Access Compliance Report

Public Rights-of-Way

(Curb Ramps)

Intersection ID: 25298	Main Street: PROVIDENCE_RD	Cross Street: WINDBLUFF_DR	Location: SW
ADA ID: 632A2D082D89	Ramp Type: BlendTrans2	Initial Pass/Fail: Fail	Overall Compliance: No
Severity Score: 10			
Codes/Mitigation Info/Possible Solution		Field Measurements/Component Compliance

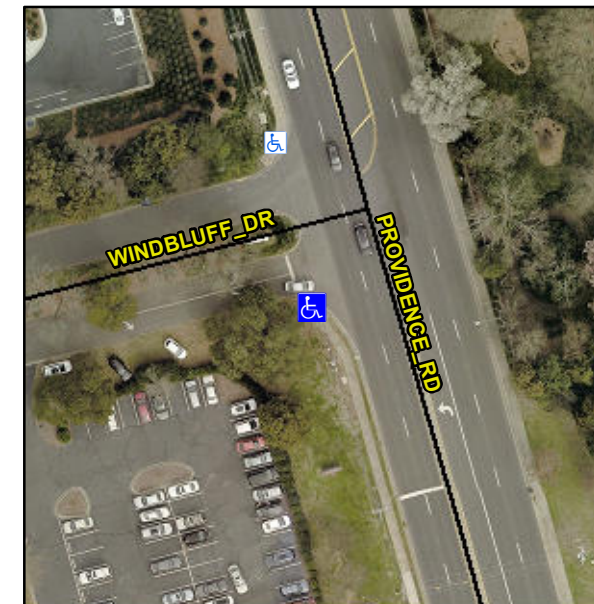
R304.5.1, R304.5.3

Compliance	Description	Data	Compliance	Description	Data
N/A	Ramp Length (in)	89.0	Yes	BlendTrans Slope (%)	3.8
No	Ramp Width (in)	42.0	No	BlendTrans XSlope (%)	4.3
N/A	Flare Type LT	N/A	N/A	Flare Type RT	N/A
N/A	Flare Slope LT (%)	N/A	N/A	Flare Slope RT (%)	N/A
N/A	Flare Traversable LT?	N/A	N/A	Flare Traversable RT?	N/A
N/A	Landing Length (in)	N/A	N/A	DWS Provided?	N/A
N/A	Landing Width (in)	N/A	N/A	DWS Contrast?	N/A
N/A	Landing Slope (%)	N/A	N/A	DWS Length (in)	N/A
N/A	Landing X Slope (%)	N/A	N/A	DWS Full Width?	N/A
N/A	Landing Curb? (Y/N)	N/A	N/A	DWS Offset (in)	N/A
N/A	Shared Landing?	N/A			
N/A	Gutter Ponding?	N/A	N/A	Gutter Slope (%)	N/A
N/A	Gutter Lip Ht (in)	N/A	N/A	Gutter X Slope (%)	N/A
N/A	Painted X Walk1?	No	N/A	Painted X Walk2?	No
	X Walk 1 Direction	To E		X Walk 2 Direction	To N
	X Walk 1 Width (in)	N/A		X Walk 2 Width (in)	N/A
	X Walk 1 Slope (%)	3.1		X Walk 2 Slope (%)	0.6
	X Walk 1 X Slope (%)	1.0		X Walk 2 X Slope (%)	5.2

Remove & Replace Curb Ramp With Two New Directional Ramps or Equivalent.
